Clarification of Additional Information for Reg. Ref. SD21A/0186

Development at Plot 100, Profile Park,
Nangor Road, Clondalkin, Dublin 22

Clarification of Additional Information Response

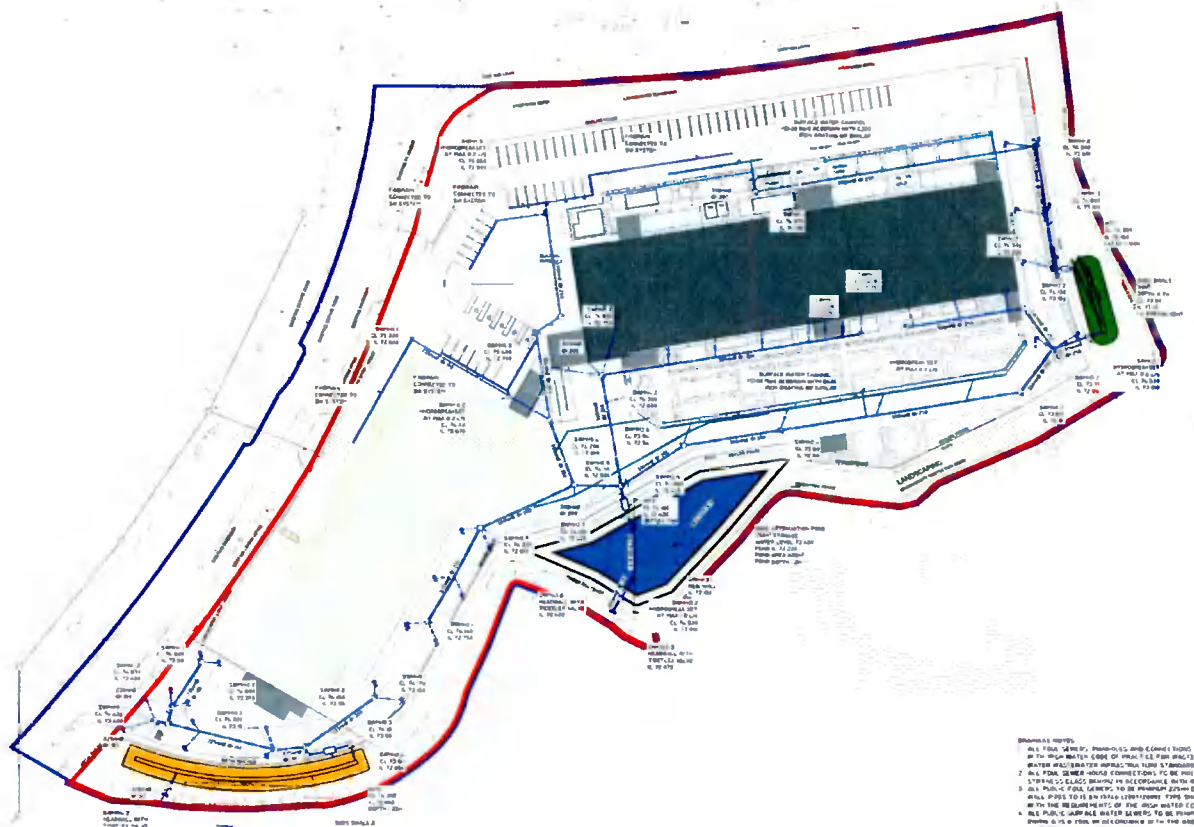
- (ii) **The applicant is required to submit Engineering drawings showing the inclusion of more SuDS for the development as outlined in Item b)i. The drawing should show how the SuDS features are incorporated with the surface water drainage network on the site. A cross sectional detail is required of all proposed SuDS features.**

In response to Item No. 1b(ii), we refer Drawing No: DBo80-PIN-00-ZZ-DR-C-PLAN-1207 Rev. P03 and Figure 2 below, which indicates the overall site reticulation network and the connections of the pipe network draining into the respective attenuation storage features.
